Service information

Reference no.: SDA_91284

Royal and Magic line, modified ratiomotor.

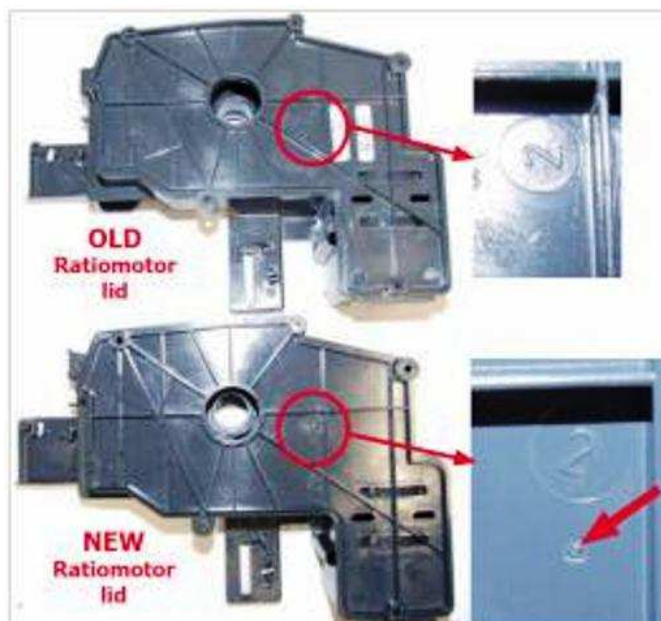
In the Royal Line and Magic Line coffee machines, from serial number TV901202001268, has been modified the wheelbase of the fastening pin to avoid the broken of gears of the brew unit positioning system..

Following the change to the wheelbase of the fastening pin (image1), if you replace the gears in a machine with serial number up to TV901202001268, you need to replace the ratiomotor lid and the ratiomotor casing assembly. For this is available the kit cod. 20007052.

The new ratiomotor lid, has a punching under the molded number (Image2), while the new ratiomotor casing has a punching and a letter "N" (Image3).
